**Planning Department
Transportation Development Services**

**Re: Range Cafe
1050 Rio Grande NW
Traffic Circulation Layout
Engineer's/Architect's Stamp dated 1-5-16 (H13-D029)**

TCL Plan

SHEET
SDP-7

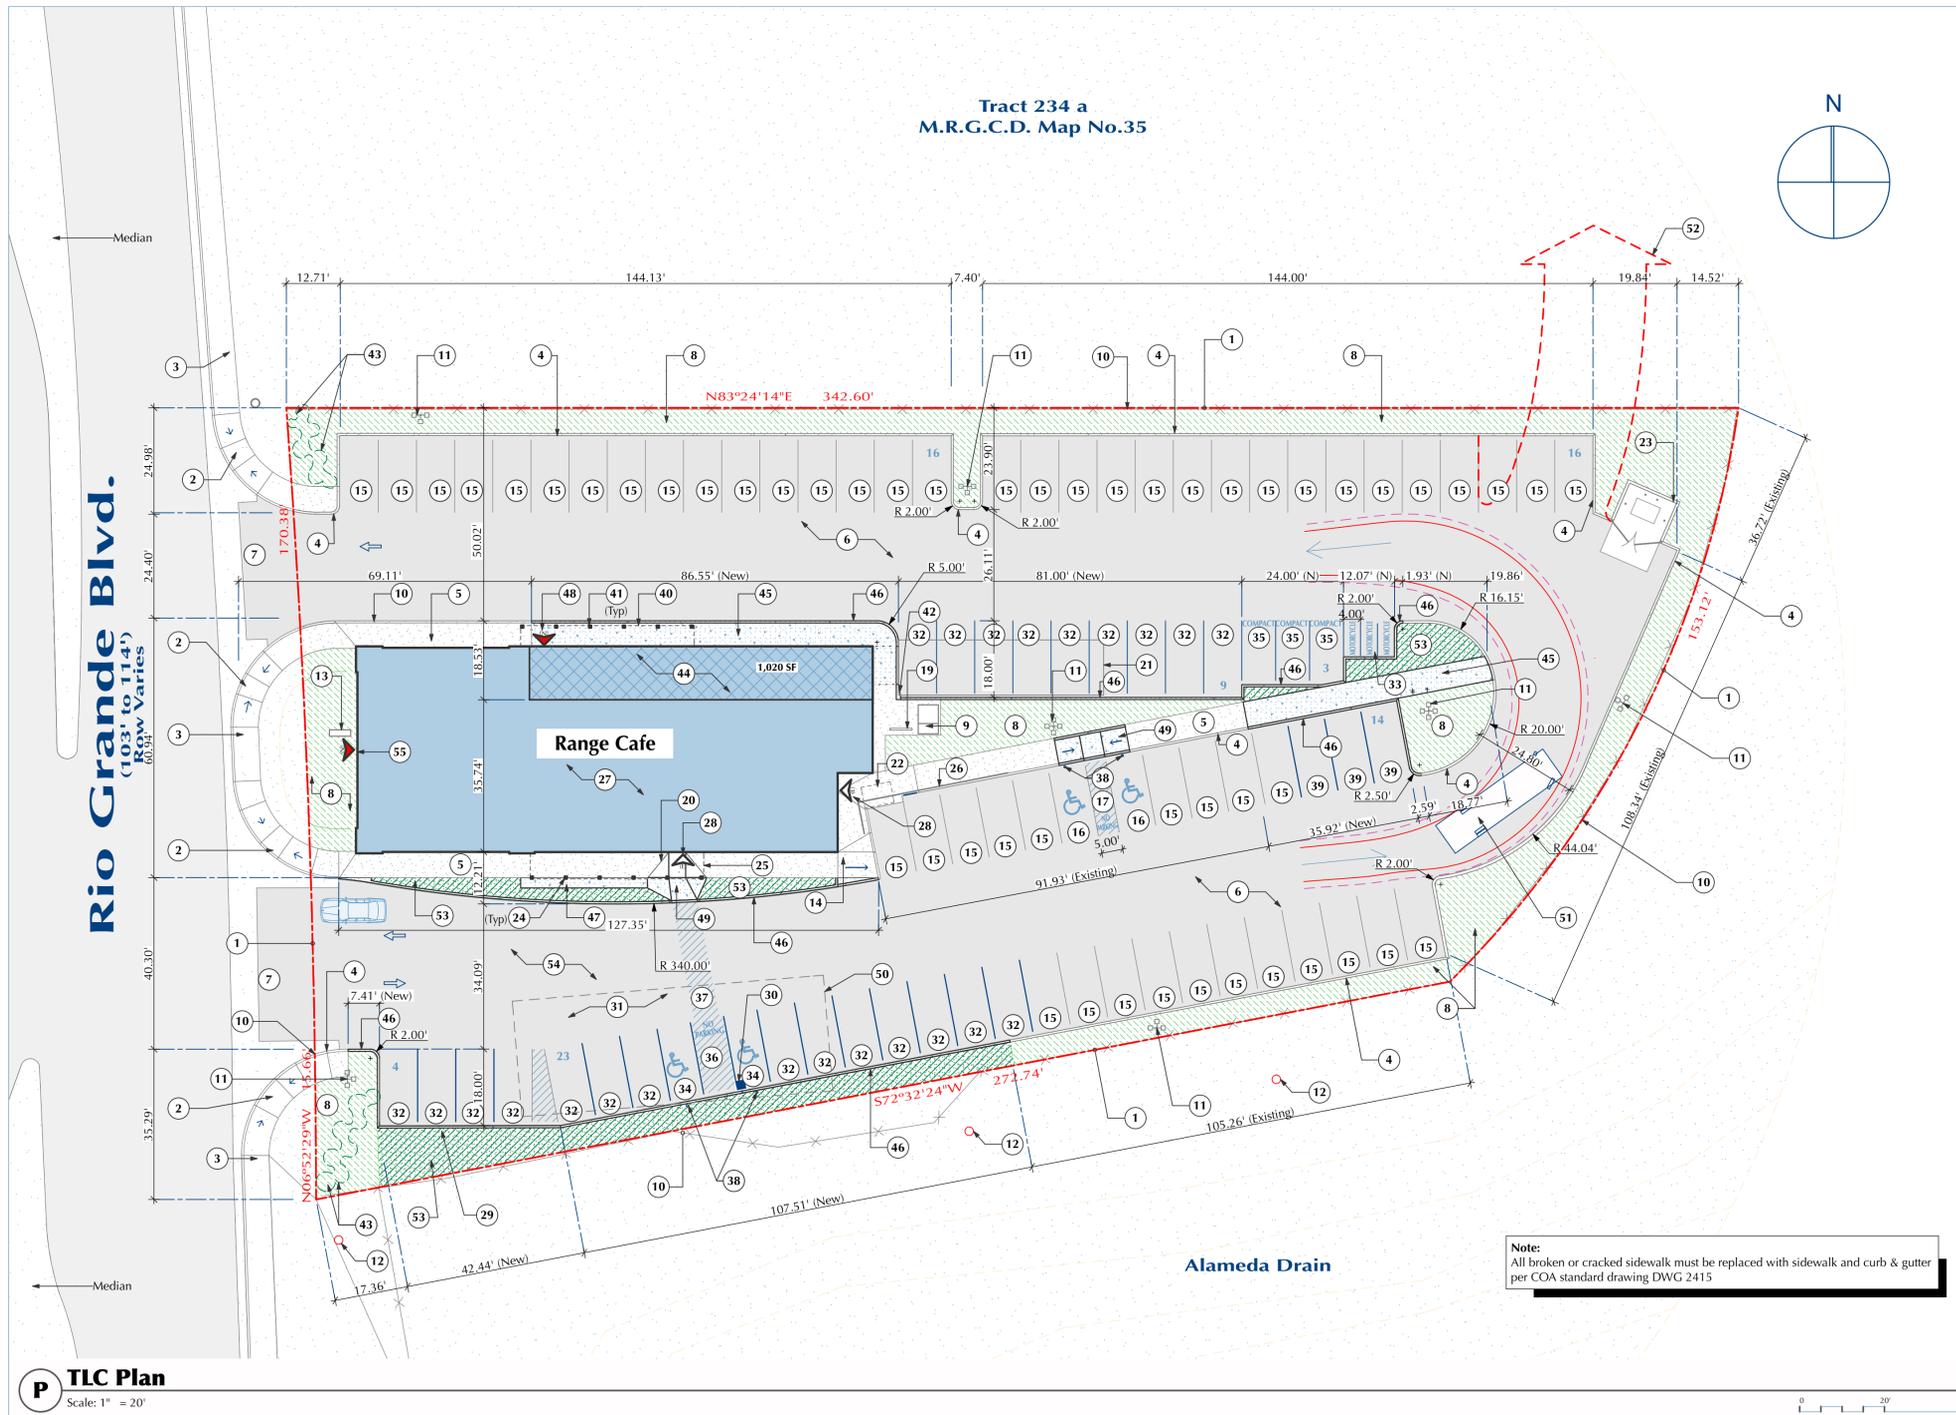
1. Please show a vicinity map showing the location of the development in relation to streets and well known landmarks.
2. Please detail and dimension all existing sidewalks, curb ramps and curb cuts on Rio Grande Blvd. to ensure compliance to ADA standards. Detail "S" on drawing refers to curb ramp on ADA access isle. Key Notes #2, 3 and 7 do not give dimension to existing northern entrance/exit, sidewalk and ramps.

3. Please dimension existing sidewalk along building. Detail "E" shows a dimension of 6 ft. for the sidewalk at the ADA access point. Please clarify width of entire sidewalk. Key Note #5 does not give a dimension.

4. The handicap accessible spaces must include an 8-foot wide van access aisle; all other aisles should be 5 feet in width. The ADA parking access isle along the building's south entrance is only shown to be 5 ft. wide, Key Note #17 calls out dimension of 8 Ft. Please clarify dimension of access isle. Also, Key Note #16 does not call out a dimension for the existing ADA parking space.

5. Please call out the distance between abutting parking spaces on the south side of building.
6. Per the DPM, a 6 ft. wide ADA accessible pedestrian pathway is required from the HC parking stall access aisles to the building entrances. Please clearly show and dimension side walk width. Key Note #5 does not give a dimension.

SHEET
SDP-8

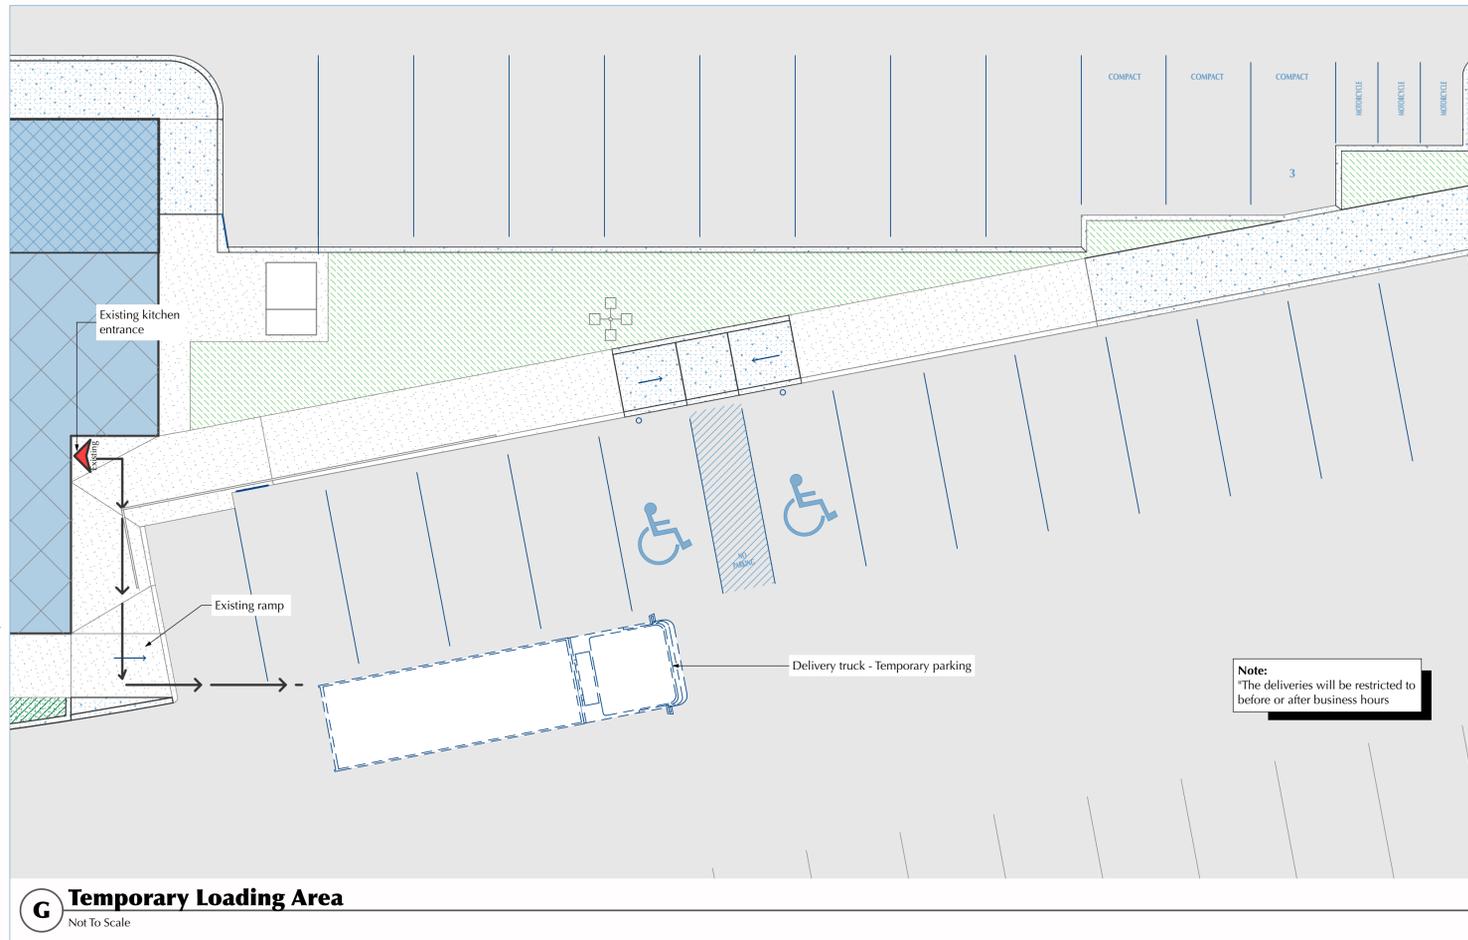
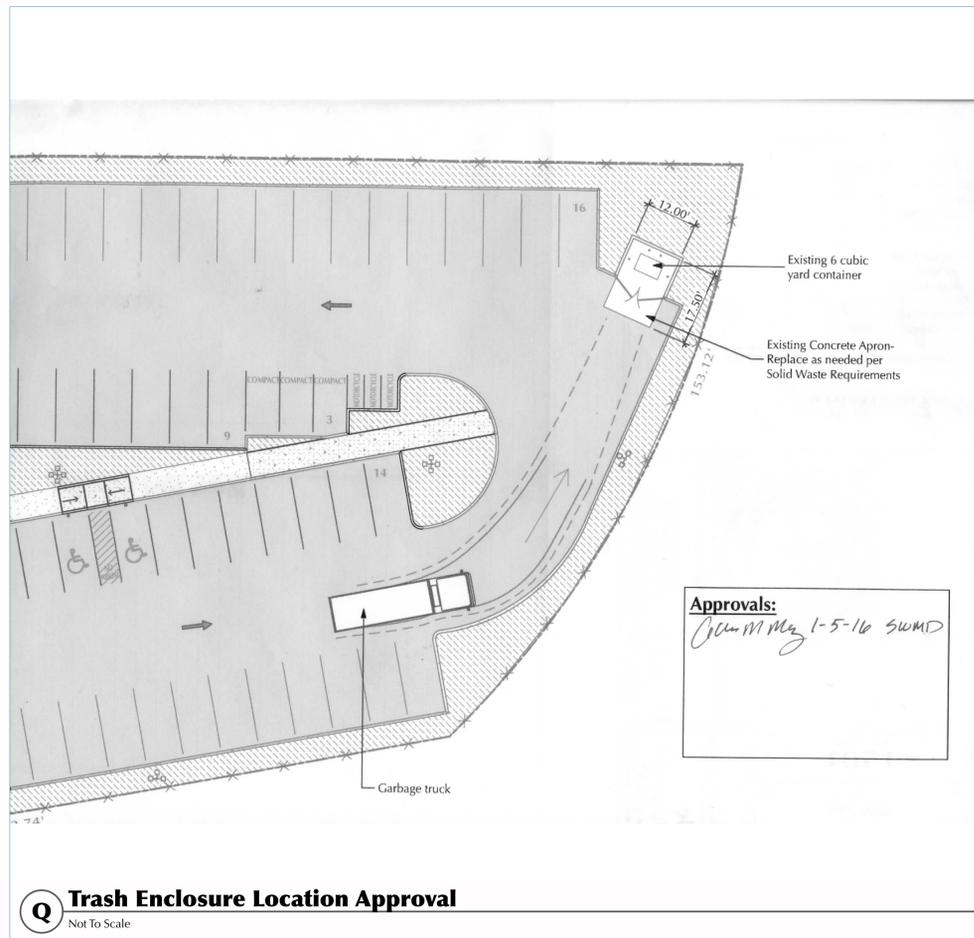
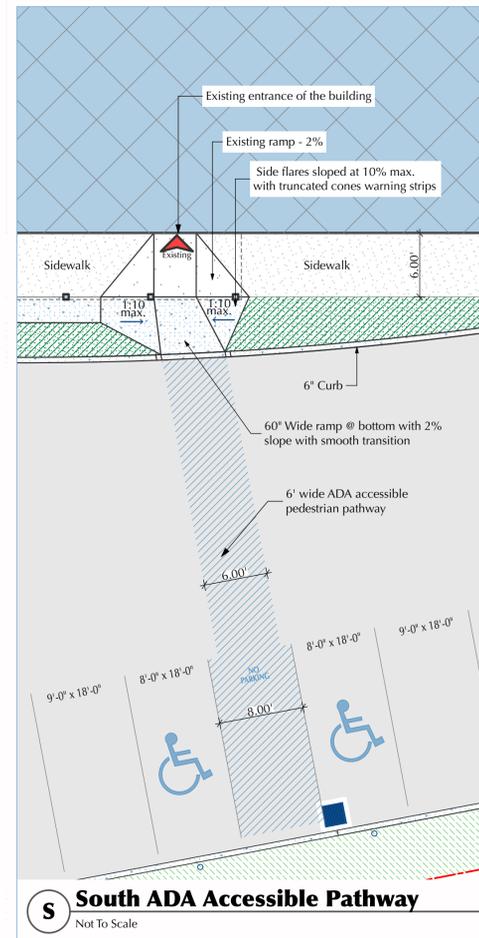
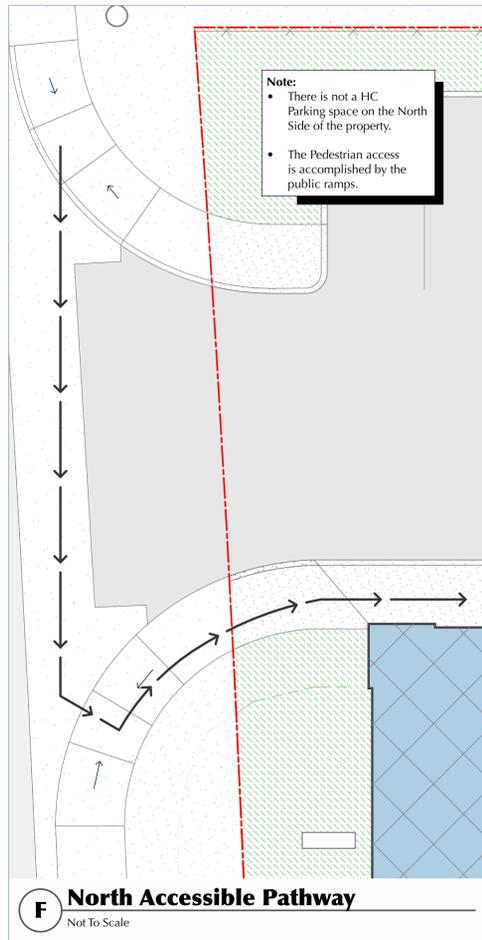
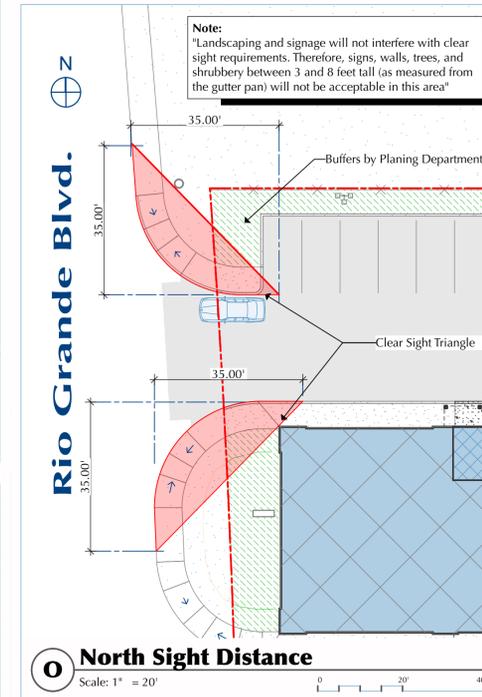
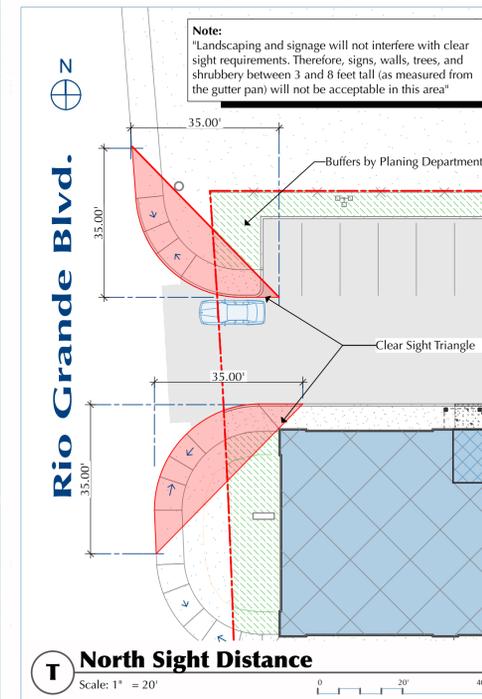
7. Please provide a sight distance exhibit (see the *Development Process Manual, Chapter 23, Section 3, Part D.5 Intersection Sight Distance*). Please show this detail for both entrances from Rio Grande Blvd. Detail "O" and "T" both detail the Clear Sight for the northern entrance.

8. Please add the following note to the clear sight triangle: "Landscaping and signage will not interfere with clear sight requirements. Therefore, signs, walls, trees, and shrubbery between 3 and 8 feet tall (as measured from the gutter pan) will not be acceptable in this area." This note must be on the drawing.
9. Future Drive Cut Key (Note #52) will require an easement and access agreement with adjacent property owner. Parking space will not be allowed in this easement area and must be subtracted from parking space calculations.
10. Please include a copy of your shared access agreement with the adjacent property owner.
11. All broken or cracked sidewalk must be replaced with sidewalk and curb & gutter. A build note must be provided referring to the appropriate City Standard drawing.
12. Please include two copies of the traffic circulation layout at the next submittal.
